Subject: Duke Energy Carolinas, LLC
William States Lee III Nuclear Station - Docket Nos. 52-018 and 52-019
AP1000 Combined License Application for the
William States Lee III Nuclear Station Units 1 and 2
Response to Request for Additional Information
Ltr# WLG2008.12-04

Lee Nuclear Station Response to Request for Additional Information (RAI)

Reference NRC RAI Numbers: ER RAIs 55 and 56

DUKES ENERGY CAROLINAS, LLC
 WILLIAM STATES LEE III
 NUCLEAR STATION
 RIVER WATER INTAKE STRUCTURE
 LOCATION PLAN

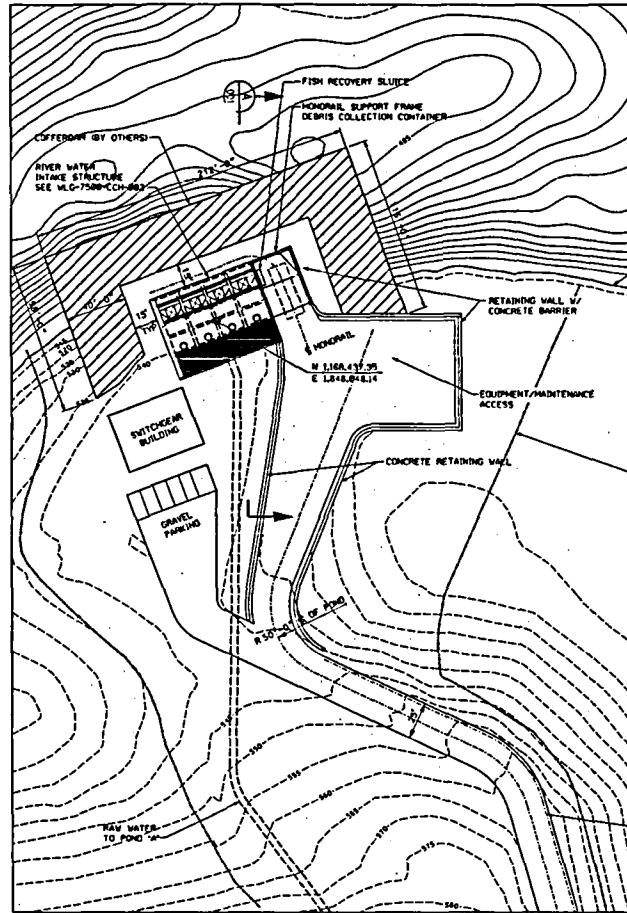
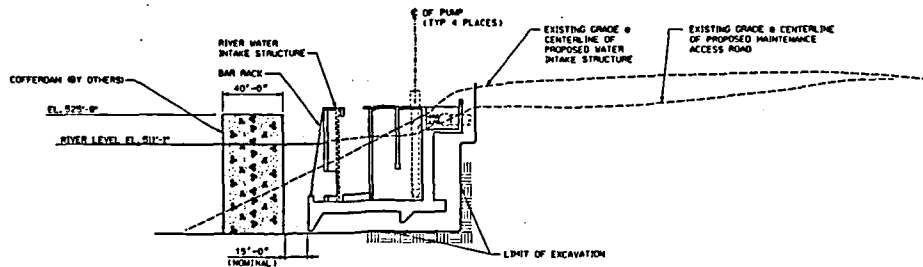
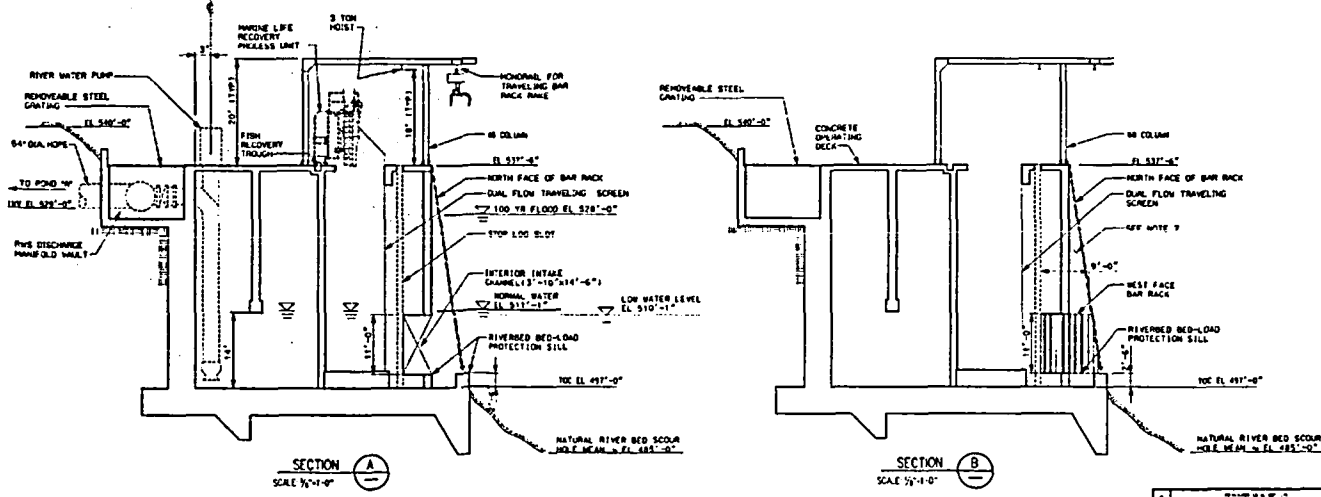
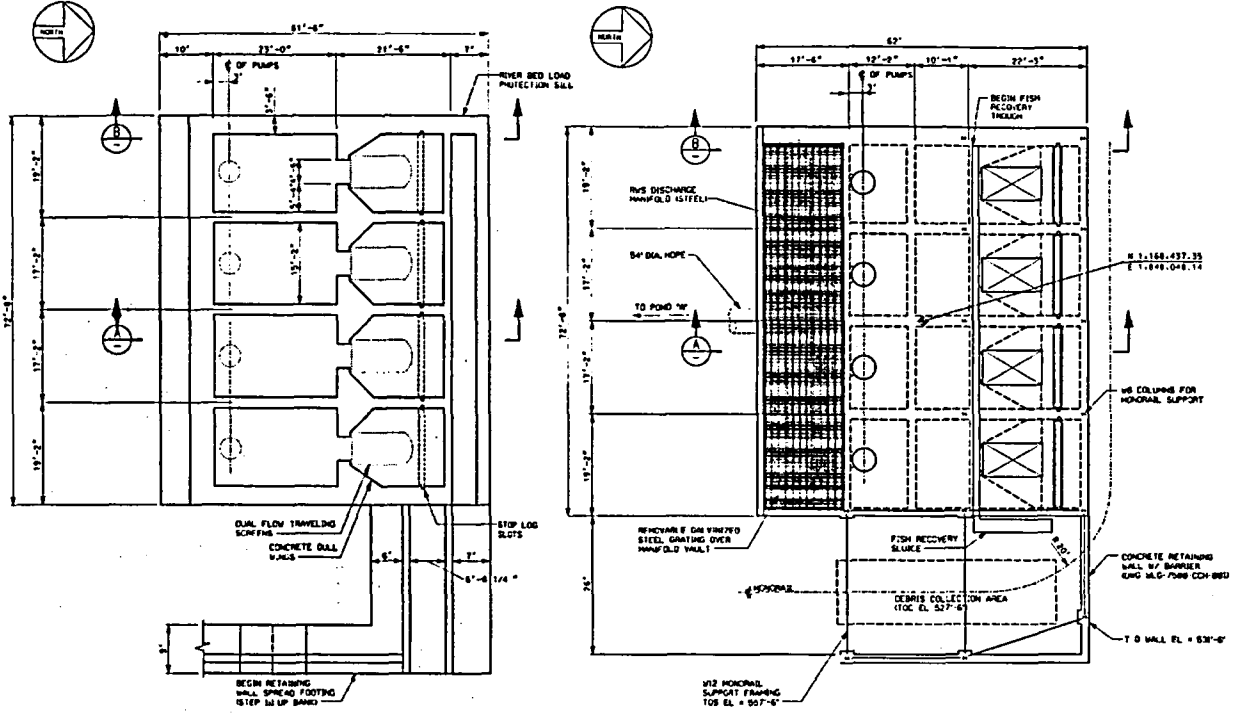
ER RAI 56: Provide the finalized cooling water intake and discharge structure design and an updated description when it is available. Include information on traveling screens and parts of the design that make it "best available technology" for protecting aquatic organisms.

Preliminary drawings of the intakes and discharge structures are attached to this response. Drawings WLG-7500-CCH-001 and WLG-7500-CCH-002 provide existing conditions, plan arrangement, plan view, and sections for the river water intake. The intake will be equipped with traveling screens, with 3/8 inch or smaller mesh, installed in the vertical position and designed for continuous operation. The screens are of the modified "Ristroph" design with Fletcher type fish-friendly buckets on each screen basket. The screens have dual pressure spray header systems with separate fish and debris troughs. The troughs are supplied with supplemental flow sufficient to move the fish and debris through the separate return troughs. The fish return trough will exit the intake on the downriver side and return the fish to the section of the Broad River. The river water traveling screens are designed to provide a through velocity that is less than 0.5 foot per second. After passing through the intake the water is conveyed by a pipe to the northwest corner of Make-Up Pond A where it is discharged into Make-Up Pond A through a surface outfall.

POND A INTAKE STRUCTURES
LOCATION PLAN

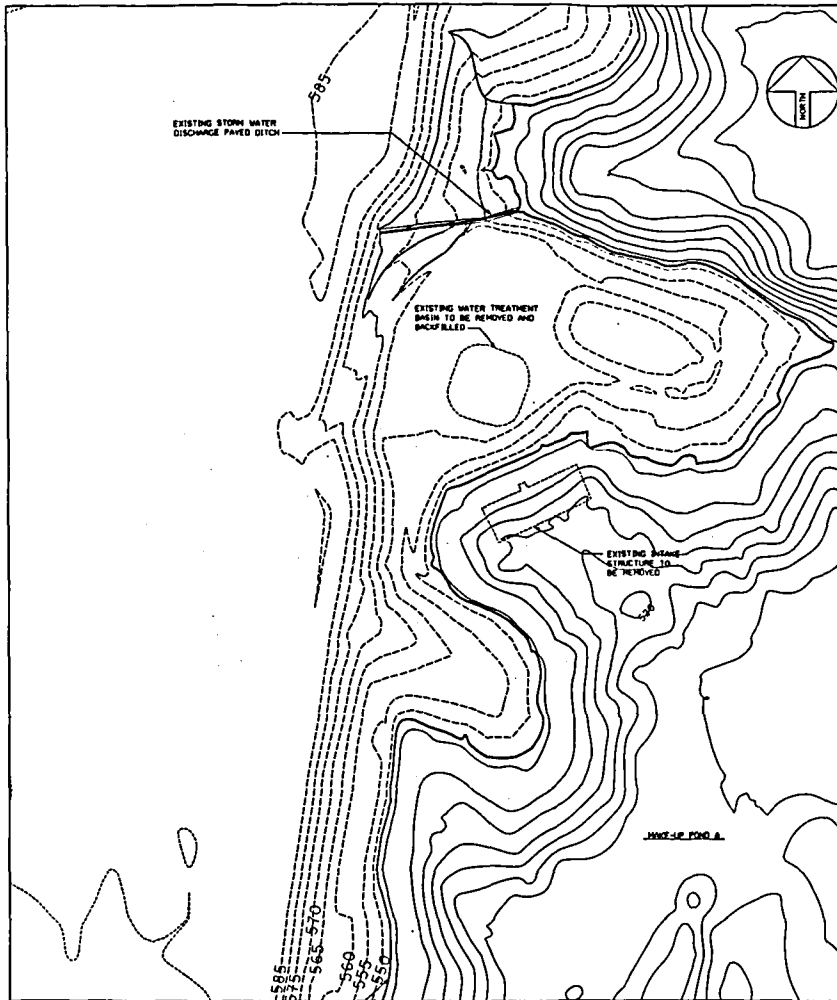
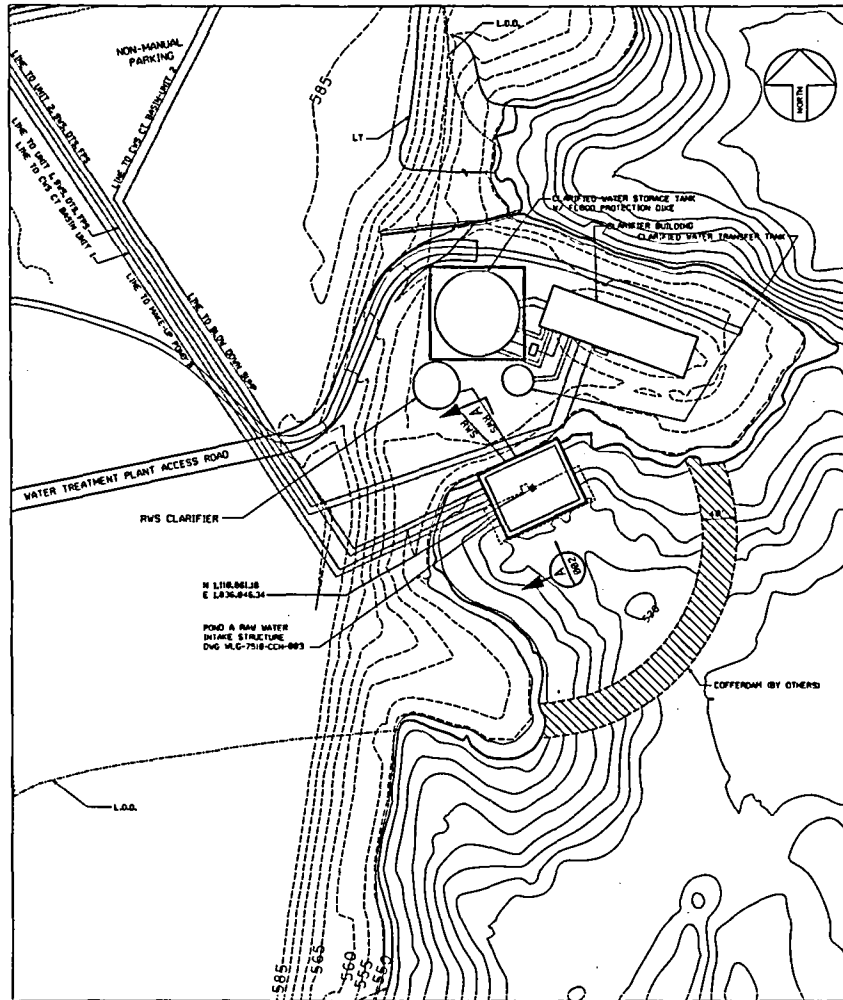
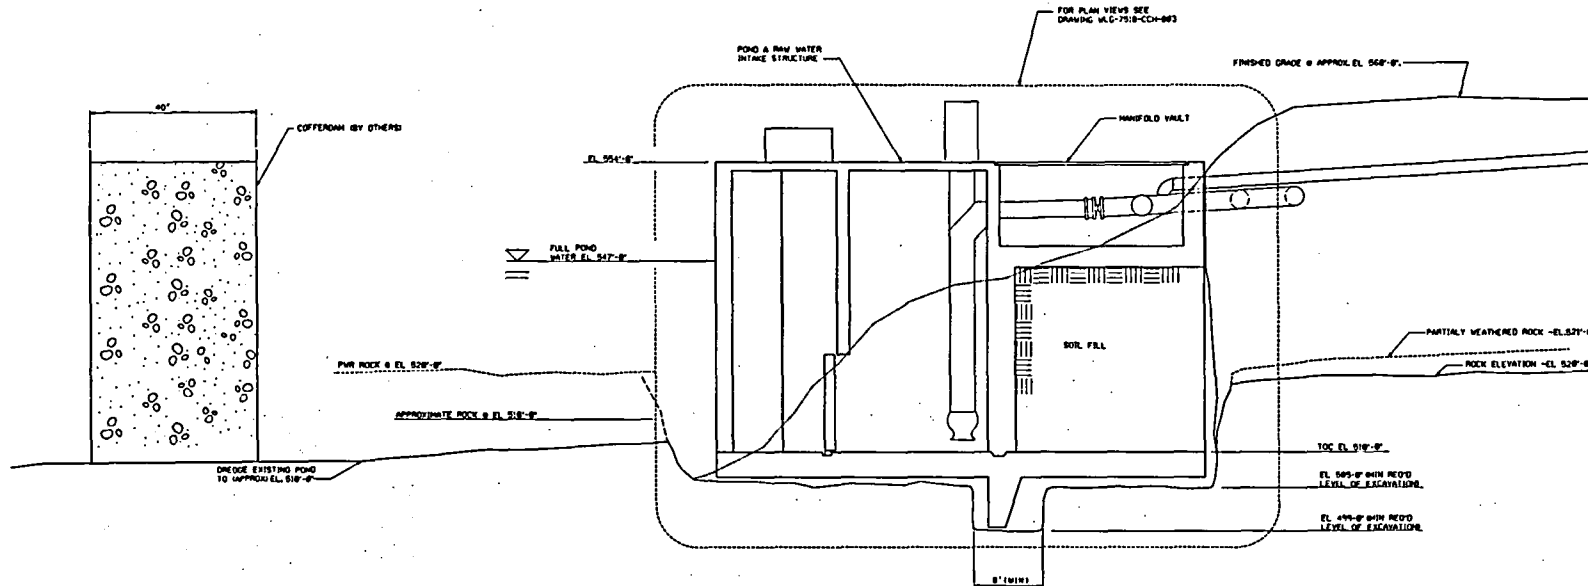
ER RAI 55: Provide the finalized Make - Up Ponds A and B intake structure designs and updated descriptions when they are available. Include information on any fish - friendly parts of the design, or indicate why they are not included in the final design.

Drawings WLG-7510-CCH-001 through WLG-7510-CCH-003 describe the Make-Up Pond A intake structure. The structure is currently designed with removable panel screens with a 3/8 inch or smaller mesh and a through-velocity that is less than 0.5 foot per second. Duke is currently evaluating the civil, mechanical and electrical requirements for the use of traveling screens similar to the traveling screens described for the river water intake.
